Addendum

Addendum No.: 1
Issue Date: September 19, 2018
Project: Martin Luther Evangelical Lutheran Church
Miscellaneous Improvements

B – CHANGES TO THE DRAWINGS

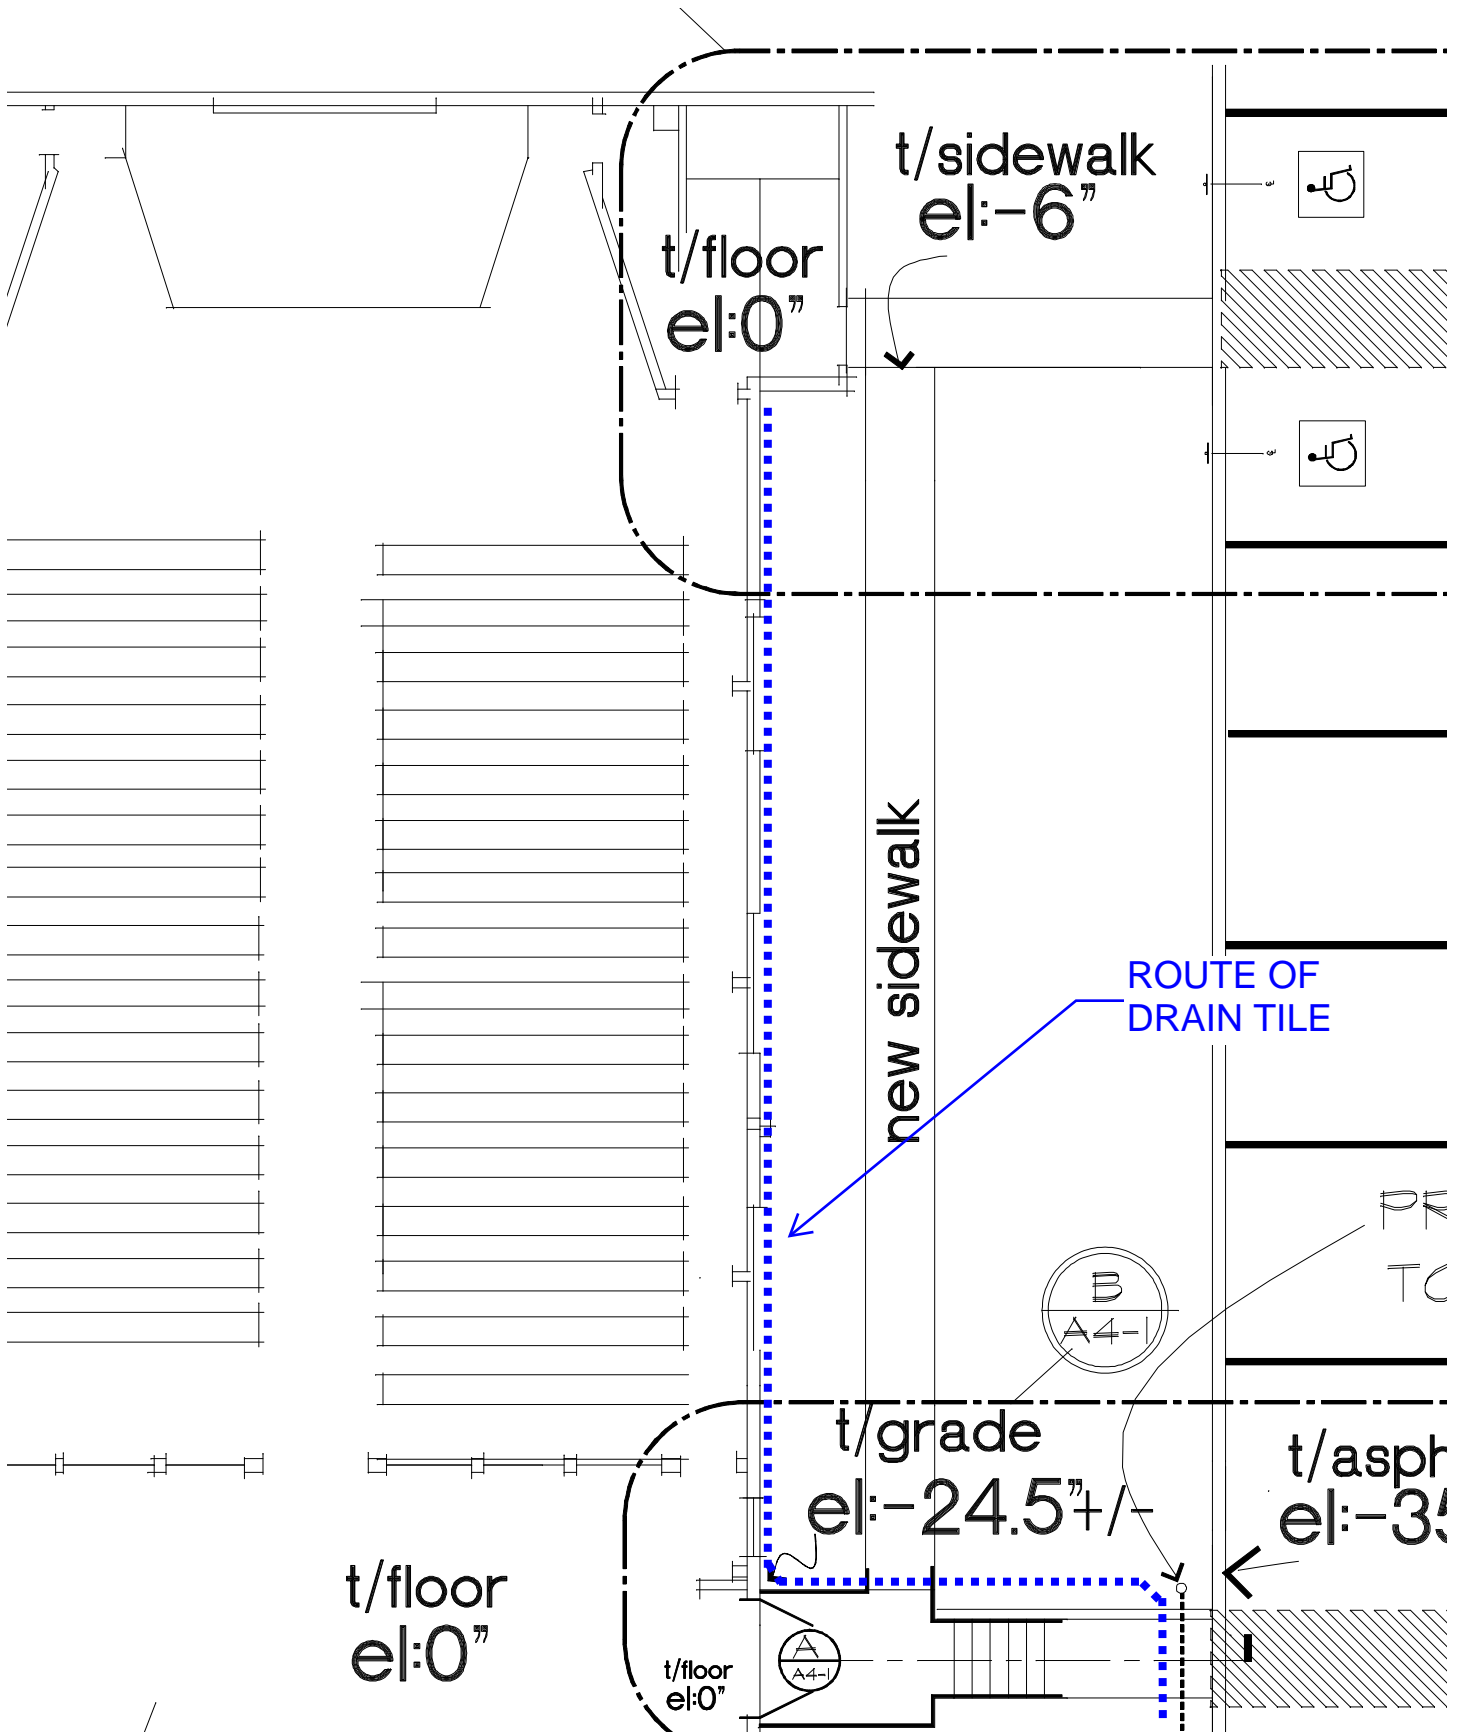
1. Sheet A0-2 SPECIFICATIONS
 - a. Change toilet partition type to be powder-coated steel.
2. Sheet A1-2 PROPOSED 1ST FLOOR PLAN
 - a. Remove keyed note 34.
3. Sheet A1-3e ELECTRICAL AND SPRINKLER
 - a. Add a 1" conduit with pull-cord between the plenum above the Kitchen ceiling and storage room on the west side of the Choir loft.
4. Sheet A4-1 SITEWORK
 - a. Scope of sitework is modified as follows:
 - i. Waterproofing to be added to side of existing building.
 - ii. Drain to be added beside building, to drain area between building and walk.
 - iii. The waterproofing is to be a 60-mil self-adhering bituminous membrane such as Carlisle's CCW MiraDRI 861.
 - iv. See attached supplemental drawings SD-01 and SD-02.

(34 CO)
BRICK VENEER W/ CORRUGATED
METAL WALL TIES EVERY
5TH COURSE @ 16" O.C. HORIZ.
(STAGGERED)

WATERPROOFING TO
PROJECT ABOVE GRADE 4"

SLOPE GRADE AWAY
FROM BUILDING MIN 1"
PER FOOT

PROVIDE GAP IN
WATERPROOFING AT
EXISTING MASONRY WEEPS

6" PERFORATED DRAIN W/ FABRIC
FILTER COVER, SET BELOW
EXISTING WEEPS. COVER W/ BED
OF GRANULAR FILL

NEW WATERPROOFING TO
LAP EXISTING
WATERPROOFING MIN. 8"
